KVRI – Forestry Subcommittee: Westside Restoration Project Updates

Comments Received: Draft EA

Proposed Action Updates

Highlighted Roadwork and Units Dropped from Final Proposal Following Comment Period on Draft EA

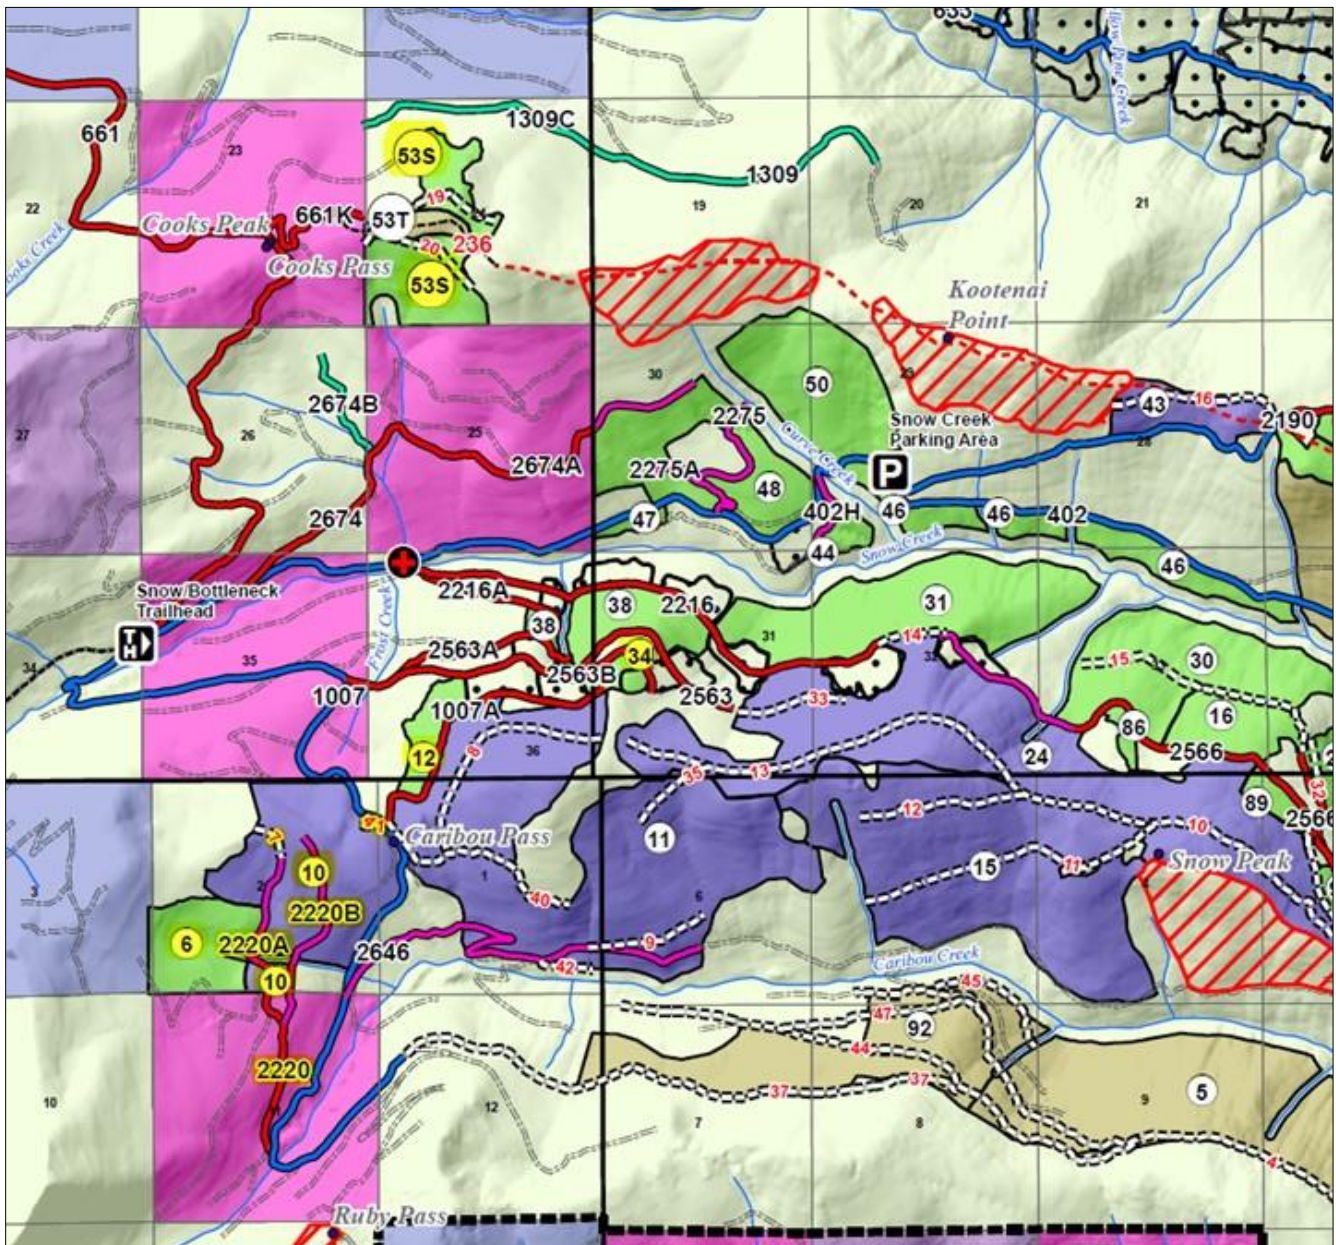
- **Reduced Timber Harvest**
 - Dropped all of harvest units 6, 10, 12, and 34
 - Dropped 140 acres of Unit 53S – 31 acres remaining and will be ground-based (previously cable). Now called Unit 53.
 - **Total harvest acres dropped from proposed action = 647 acres**
 - **Final proposed harvest**

- **Reduced Temporary Road Segments/Miles:** Dropped 2 temporary roads (no longer needed) and 0.32 miles – Temp Roads 7 and 41
- **Reduced Road Reconstruction:** 2.4 miles less proposed road reconstruction needed – Road 2220
- **Reduced Road Storage:** 1.6 miles less proposed storage – Roads 2220A and 2220B
